FALCON RESERVE FILING NO. 1
COUNTY OF EL PASO, STATE OF COLORADO
WATER & SANITARY UTILITY PLANS
JULY 2026

WATER & SANITARY UTILITY PLANS

PROJECT NO. 44-1444

SHEET 1 OF 14

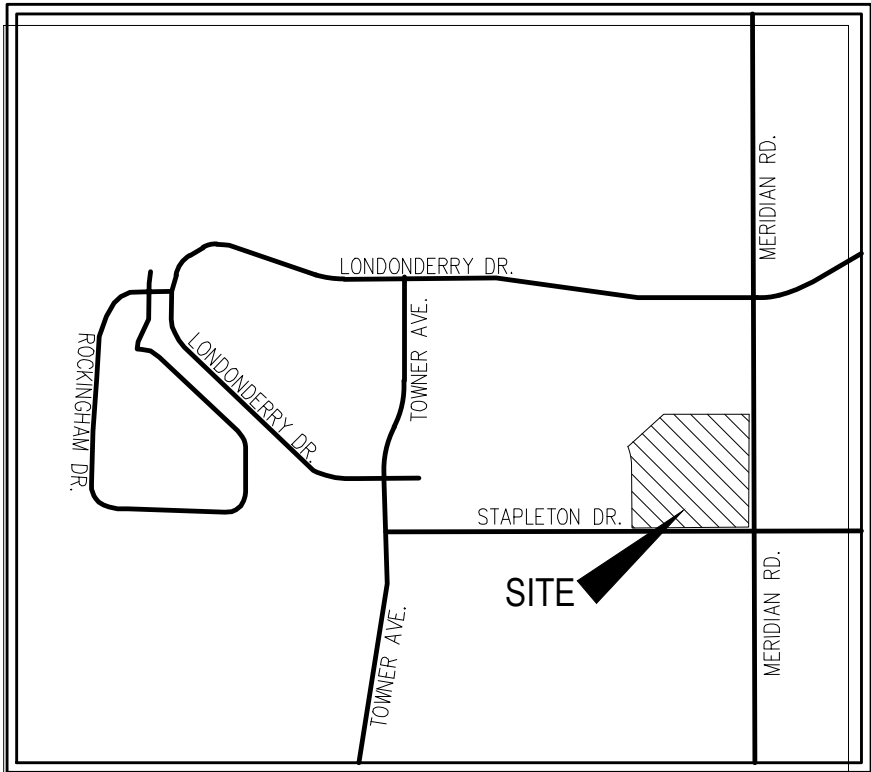
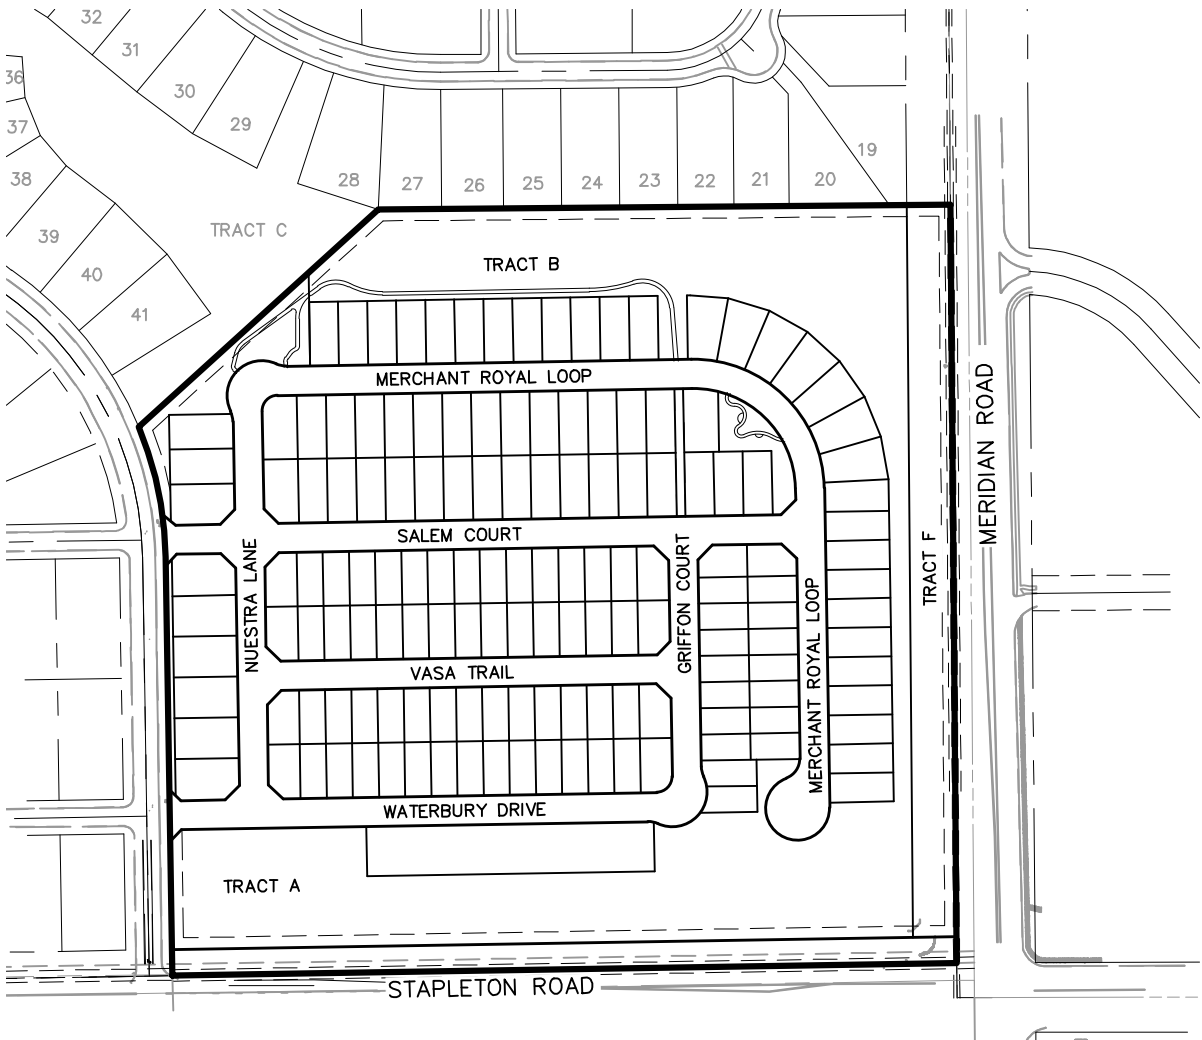
Add gas line plan and UGE
